**STAFF REPORT**  
**COMMUNITY DEVELOPMENT DEPARTMENT**

SUBJECT: Southridge South No. 1  
MFP-2025-0002

Modification to the final plat (FP-2021-0059) approval to change the fencing type along the Ridenbaugh Canal from black wrought iron as required by City Council, to black open vision vinyl-coated chain link with posts installed in sleeves for easy removal as required by NMID.

### A. Final Plat (dated: 5/5/25)

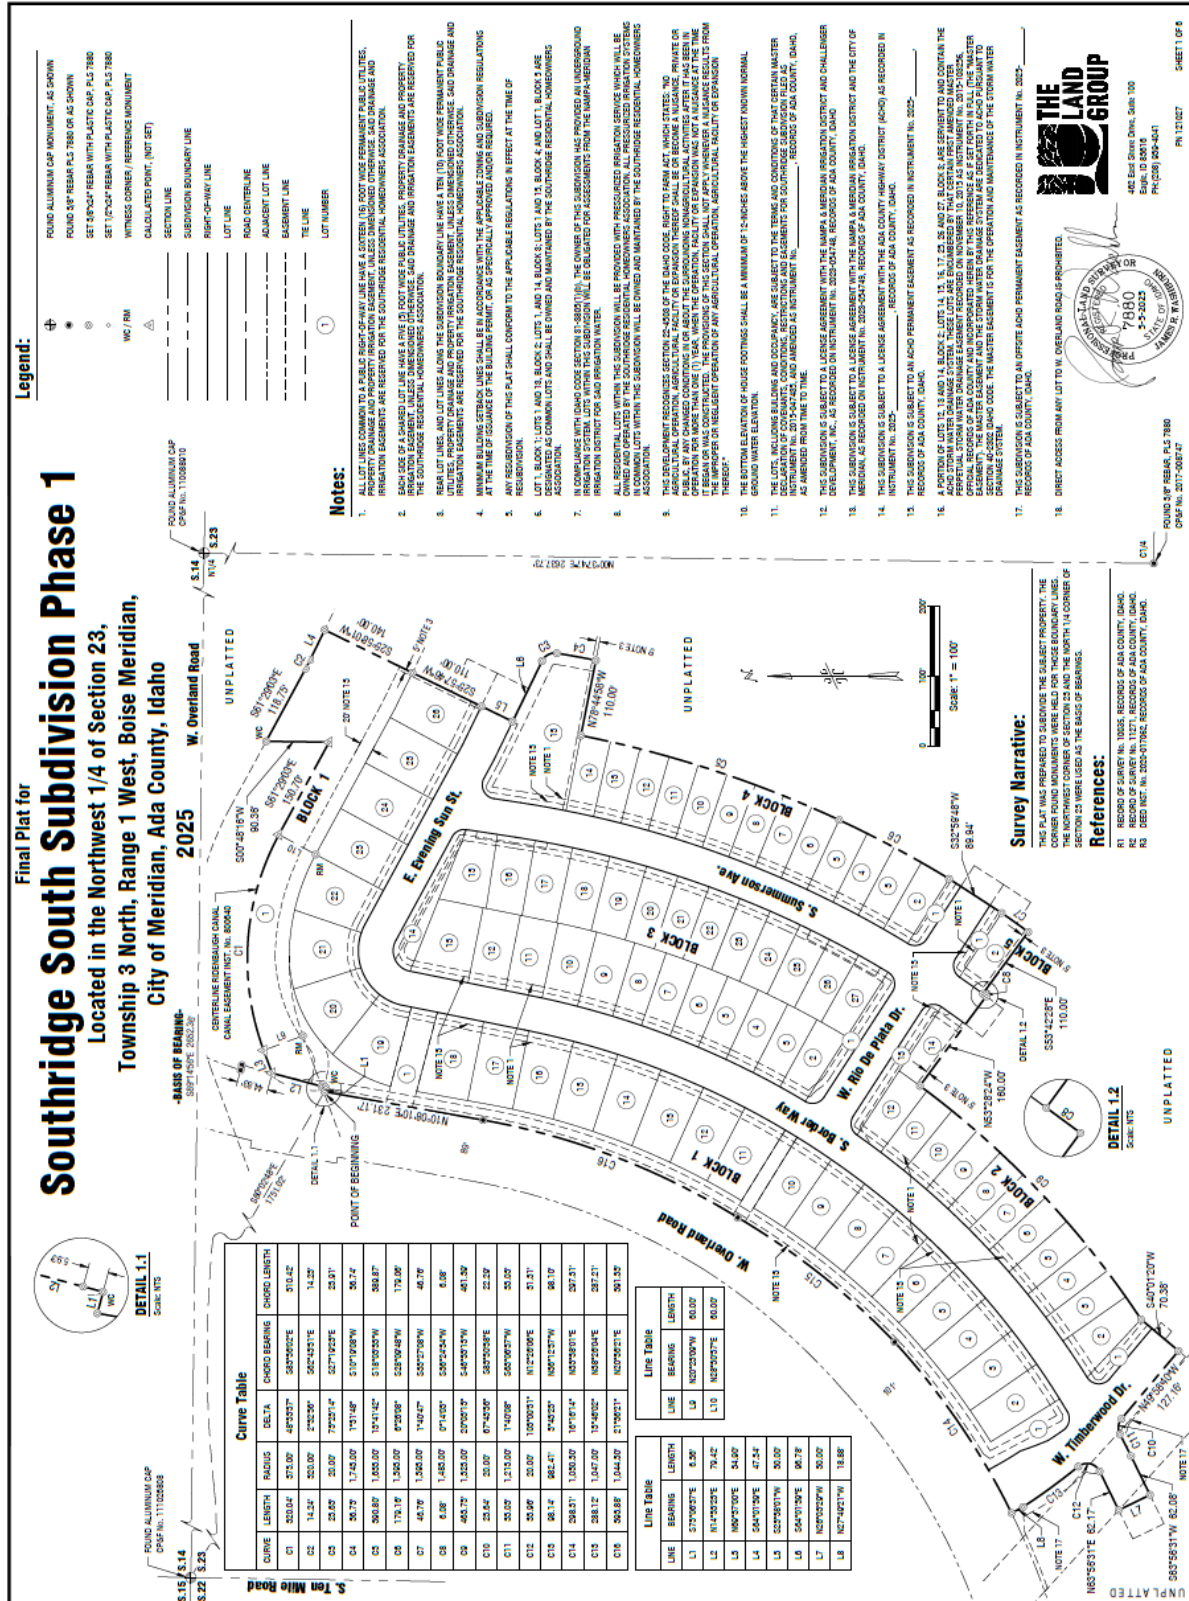
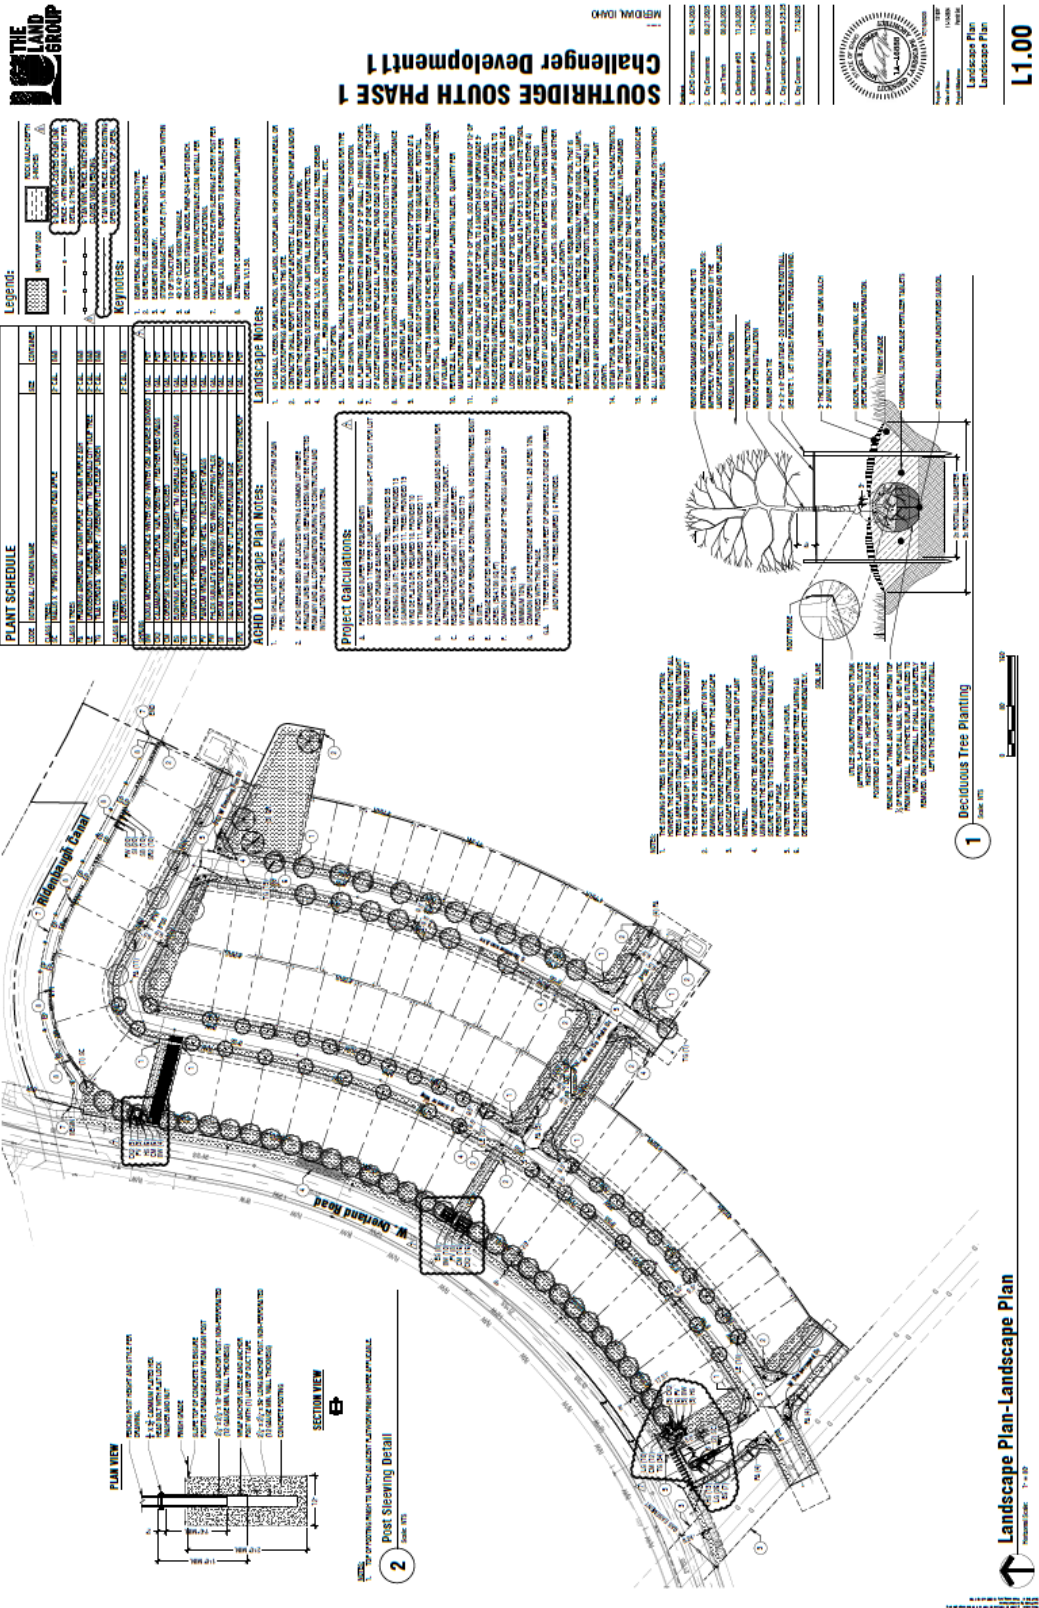
The Applicant requests City Council's approval to modify final plat condition #5d, as follows:

*The fencing type along the Ridenbaugh Canal shall be black ~~wrought iron~~ open vision vinyl-coated chain link as ~~required~~ approved by City Council with MFP-2025-0002; depict accordingly.*

Final plat condition of approval #5.d, shall be amended as follows:

*The fencing type along the Ridenbaugh Canal shall be black ~~wrought iron~~ open vision vinyl-coated chain link as ~~required~~ approved by City Council with MFP-2025-0002; depict accordingly.*
